Design Review Committee Meeting

October 6, 2021 6:00 PM

4.I. 816 South Central Avenue Design Modification

4.II. 3165 Dogwood Drive New Townhomes

Picture of As-Built stairs (3ft offset):

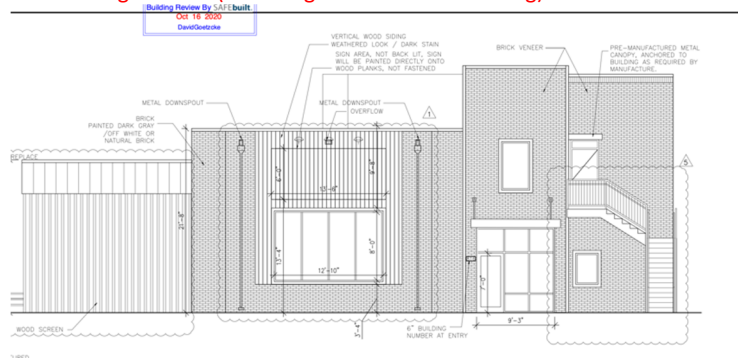
* Egress stairs @ right of building extending off building line.

Original Plan (stairs align with back of building)

Picture of As-Built stairs

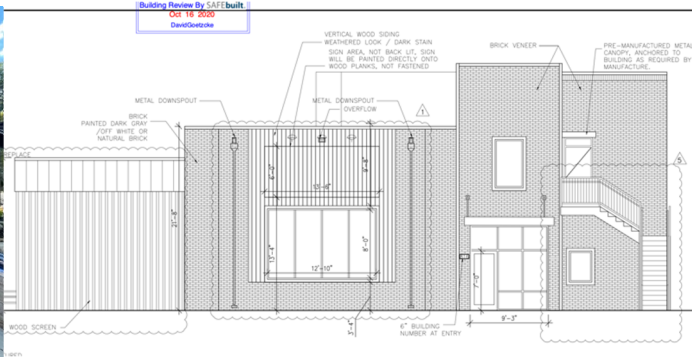
* Steps leading to main entrance not shown on revised plans.

Original Plan (no stairs shown)

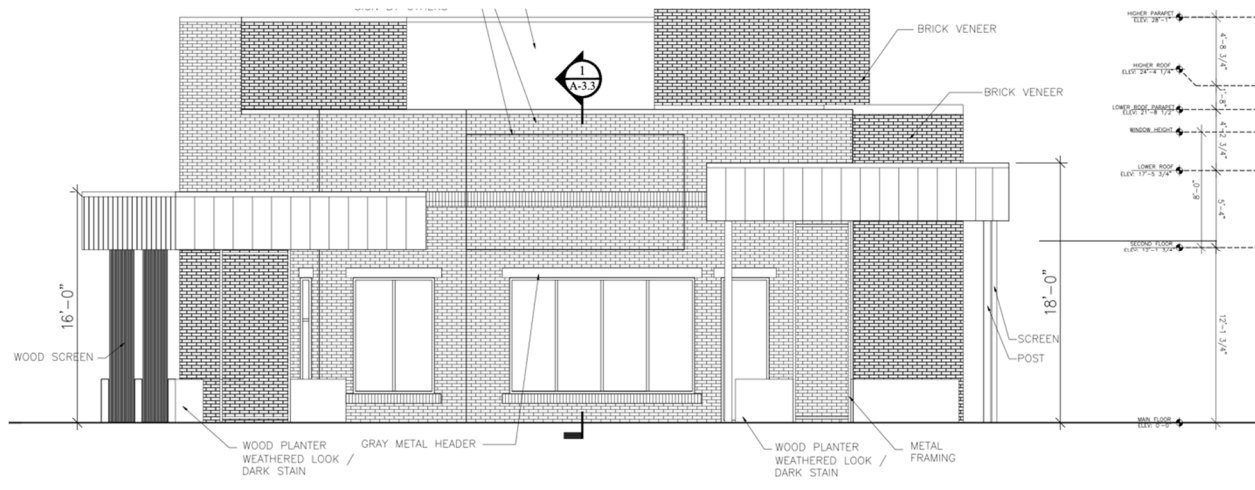
* Canopy finishes do not reflect approved revised plans.

See below as-is photograph showing thinner fascia for canopies. Wood slats under current construction (waiting on steel mounts to be delivered and installed). Additional design detail for canopy screening provided in email.
